Re: Clean Water Act, Section 308 Request for Information

The enclosed Request for Information is issued this date pursuant to Section 308 of the Clean Water Act, 33 U.S.C. § 1318 and requires, among other things, that Pepco-Benning Generating Station provide information regarding closure of the facility and NPDES discharges associated with NPDES Permit No. DC0000094. The requirement to provide information to the U.S. Environmental Protection Agency is mandatory. You must respond in accordance with the instructions and milestones set forth in the Request for Information.

PCB and Iron Source Tracking Pollutant Minimization Plan

Figure
Number:
B-1

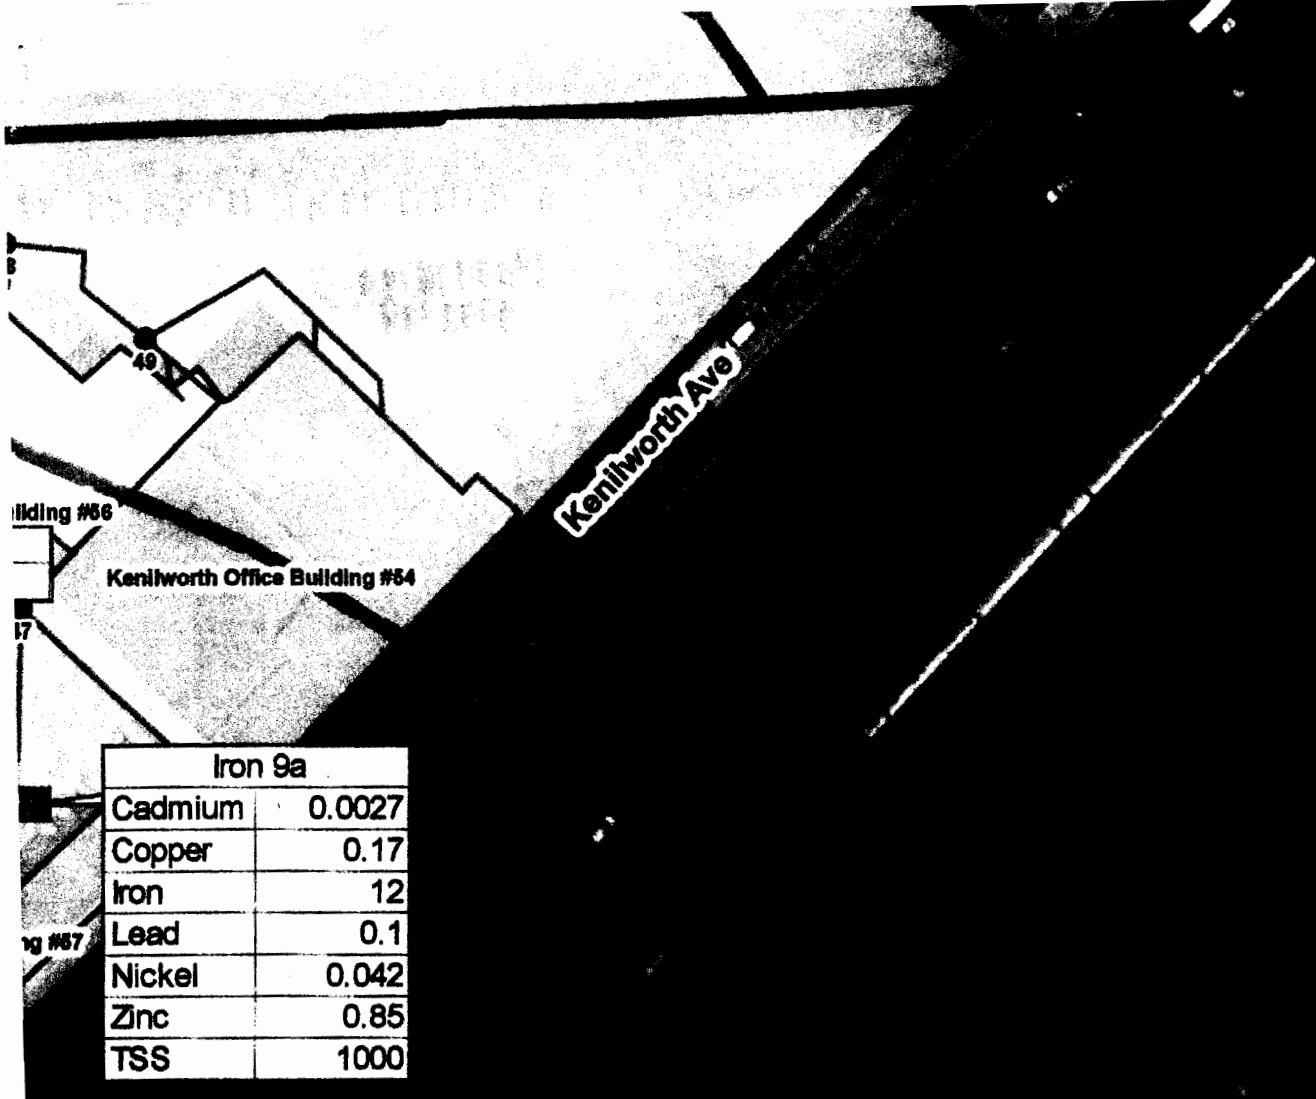
Response: AMEC conducted two storm water sampling events in May and September 2011 as referenced in response to question 17 (d). Sampling event 1 results indicated that the highest concentrations of metals, specifically Iron, were detected at sampling locations identified as Iron 2, Iron 3, Iron 5 and Iron 9a. The locations of these sampling points are depicted on Figure B-1 from AMEC's May 2012 status report. A copy of Figure B-1 is provided at **Attachment 4**. Sampling location Iron 8 had an elevated level of Zinc. During sampling event 2, all these locations were resampled to verify that the elevated metal concentrations were present. To narrow down potential source areas of metals, additional locations within the catchment areas of Iron 2, Iron 3 and Iron 5 were sampled. The catchment area containing Iron 2 was sampled at Iron 2a, Iron 2b, Iron 2c, and Iron 2d. The catchment area containing Iron 3 was sampled at Iron 3a.

Results from sampling event 2 indicated that the highest iron concentrations occurred at Iron 2, Iron 2a, Iron 2c, Iron 2d, Iron 3a, Iron 5 and Iron 9a. Elevated Lead and Zinc concentrations were also found at Iron 3a. TSS was the highest at Iron 2, Iron 2a, Iron 2c, Iron 3a, Iron 5 and Iron 9a. The locations of these sampling points are depicted on Figure B-7 from AMEC's May 2012 status report. A copy of Figure B-7 is provided at **Attachment 5**.
